HISTORIC AND DESIGN REVIEW COMMISSION

May 15, 2019

HDRC CASE NO: 2019-251
ADDRESS: 125 BUFORD
LEGAL DESCRIPTION: NCB 1369 BLK 6 LOT S 60 FT OF 7
ZONING: R-4, H
CITY COUNCIL DIST.: 2
DISTRICT: Dignowity Hill Historic District
APPLICANT: Fernando Cornier/CANDC Contracting
OWNER: Fernando Cornier/CANDC Contracting
TYPE OF WORK: Fenestration modifications, exterior modifications
APPLICATION RECEIVED: April 18, 2019
60-DAY REVIEW: June 17, 2019
CASE MANAGER: Huy Pham

DOOR

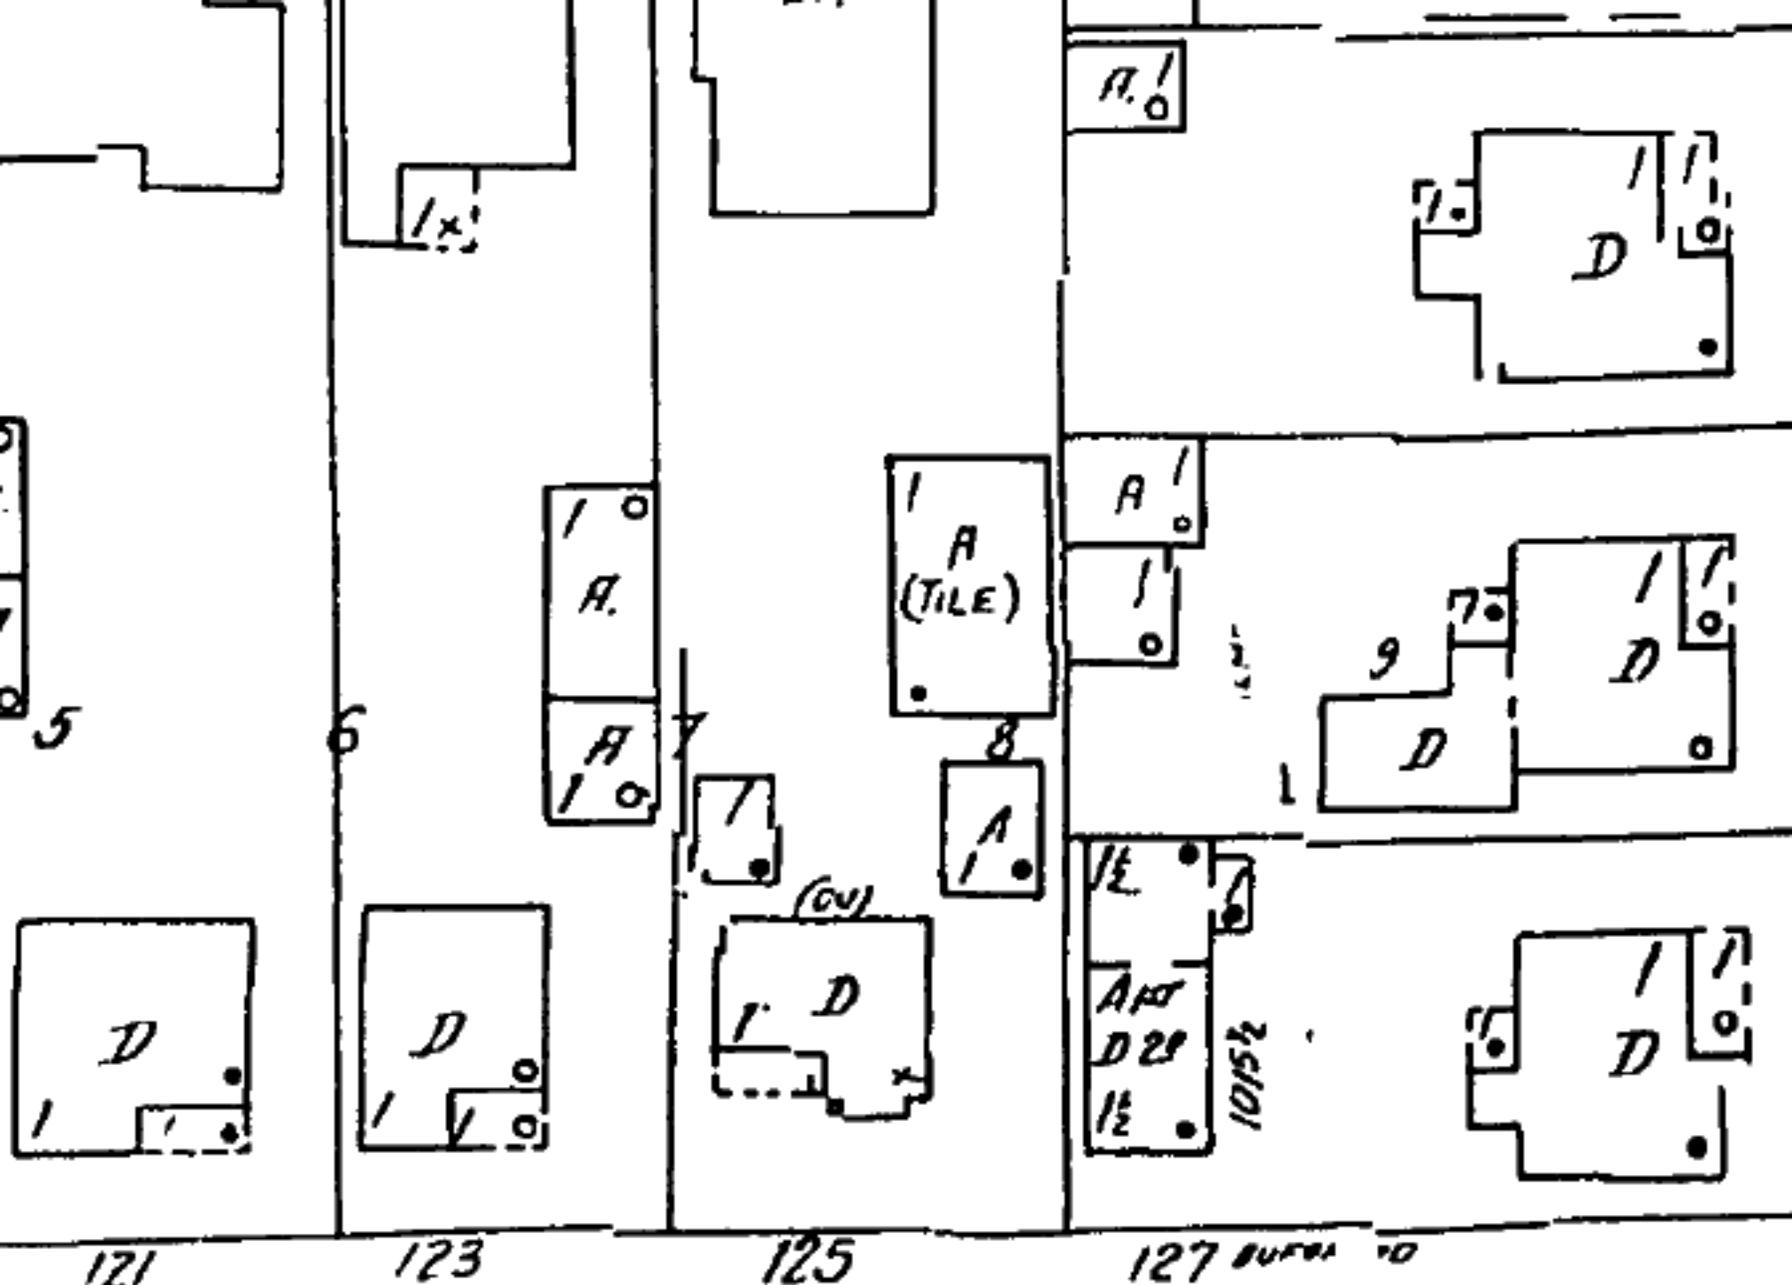
- d. **DOOR RELOCATION** – The applicant has proposed to relocate an existing east side elevation door to the rear elevation of the structure. Per the Guidelines 6.A.i, historic doors and windows openings should be preserved. Staff finds that the existing side door is atypical of historic structures of this style and is not a character defining feature. Staff finds that the proposed relocation to the rear is appropriate.

Staff recommends approval of relocating the side door to the rear based on finding d with the stipulation that infill should match in siding, trim, and configuration.
